**Review of the United States Environmental Protection Agency DRAFT Report  
Entitled  
"Investigation of Ground Water Contamination near Pavillion, Wyoming"**

**Encana Oil & Gas (USA) Inc.  
370 17<sup>th</sup> Street, Suite 1700  
Denver, Colorado 80202**

**Robert J. Sterrett, Ph.D.  
Itasca Denver, Inc.  
Lakewood, Colorado**

**March 2012**

# USEPA Figure 20 Cross Section in Core Area

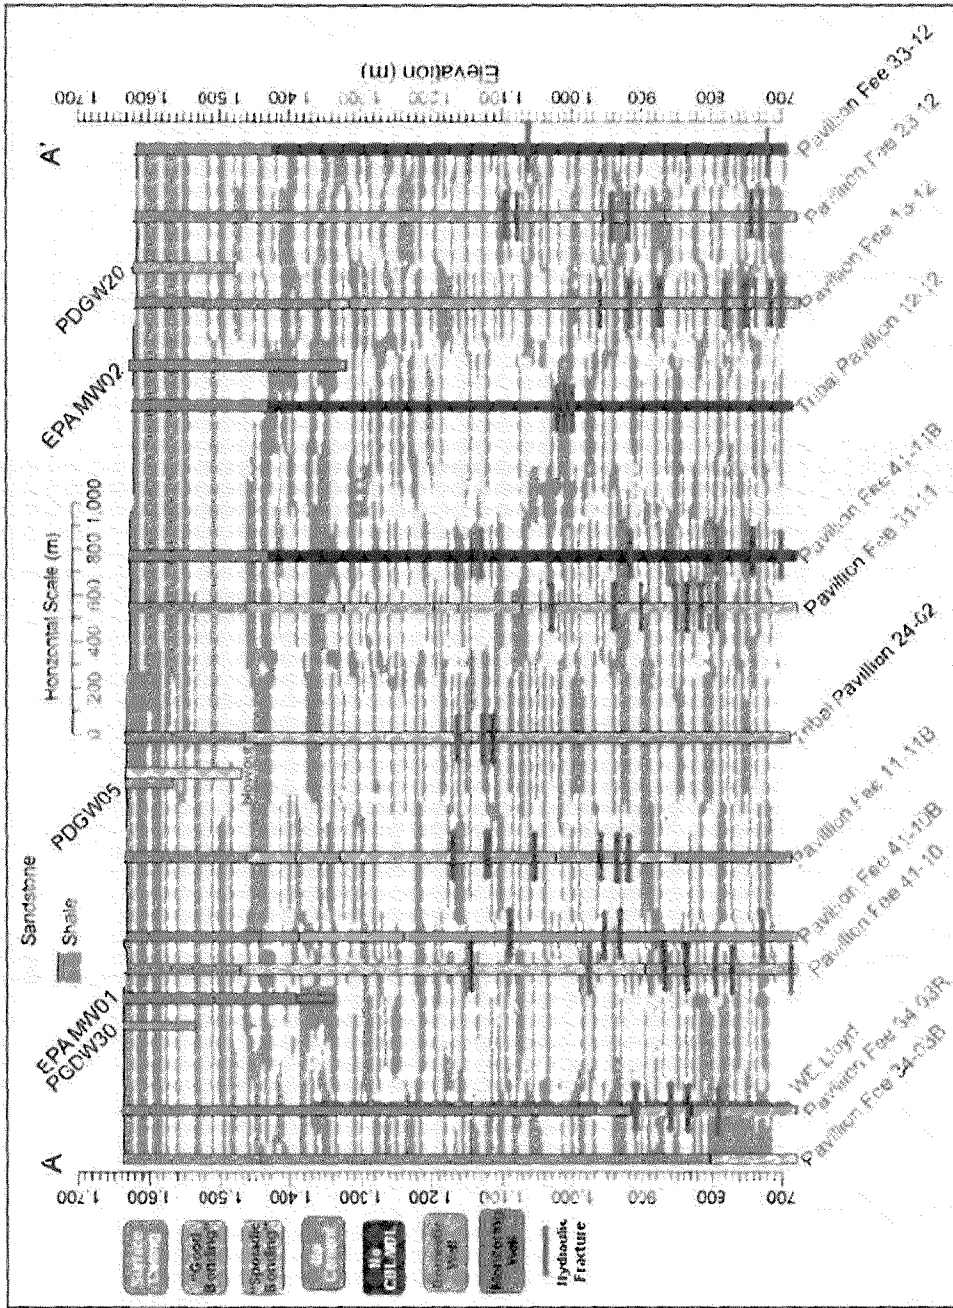
Figure 20 of the USEPA Draft Report (see Figure RJS-7 of my report) depicts there are thick, continuous sandstone layers throughout the core area especially at shallow depth. This is not the case. The quality of this figure in the Draft Report is poor, and how the correlations are derived is unknown. The geologic model shown by the USEPA in their Draft Report is counter to geologic interpretations provided by geologists working for the USGS and industry. Figure RJS-8 shows the location of USEPA's cross section superimposed upon a structural contour map of the top of the Fort Union Formation. The structural contour map has been modified from that provided by Bjorklund (1978) (Figure RJS-5) by the addition of faults. The locations of these faults have been interpreted based on additional information since Bjorklund's paper in 1978.
